Agenda
Hailey Planning and Zoning Commission
Monday, June 2, 2025
5:30 p.m.

STAFF REPORT
Hailey Planning and Zoning Commission
Regular Meeting of June 2, 2025

Overview: Reconsideration of a Design Review Application, submitted by Overland West, Inc., represented by Jay Cone Architecture, with the proposal to relocate the approved fuel tank. This project is located at 1551 Aviation Drive (Lot 3A, Block 34, Airport West Subdivision #2) within the SCI - Industrial (SC-I) Zoning District.

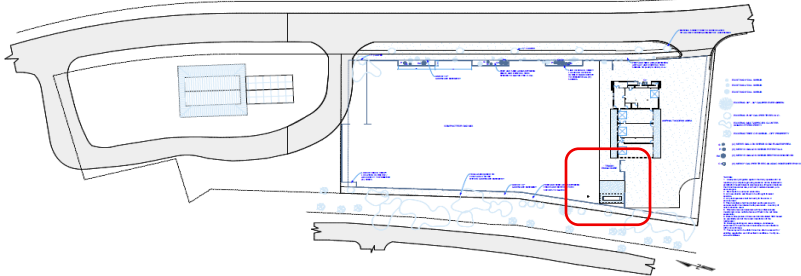
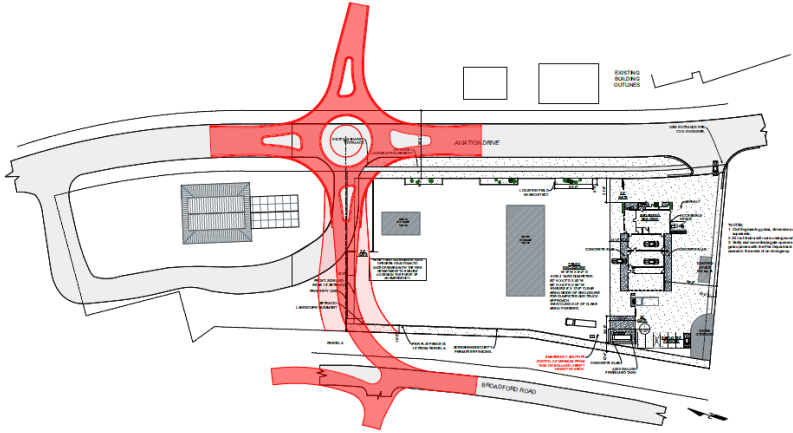
Compliant			Standards and Staff Comments	
Yes	No	N/A	City Code	City Standards and <i>Staff Comments</i>
<input checked="" type="checkbox"/>	<input type="checkbox"/>	<input type="checkbox"/>	17.06.080(D)1a	a. The location of the buildings shall respond to the specific site conditions, such as topography, street corners, open space and existing and planned adjacent uses.
			<i>Staff Comments</i>	<i>The fuel tank has been relocated to the southwestern corner of the lot and placed on a larger integrated support and access pad. The light, signs, and bollards have been adjusted accordingly. Large vehicle access to the above ground fuel tank is essential. To ensure access, the tank will be relocated, the building shifted west, and access to Aviation Drive has been redesigned. These modifications will provide the property owners with various options to accommodate future improvements, along with options to subdivide the property, if so desired.</i>
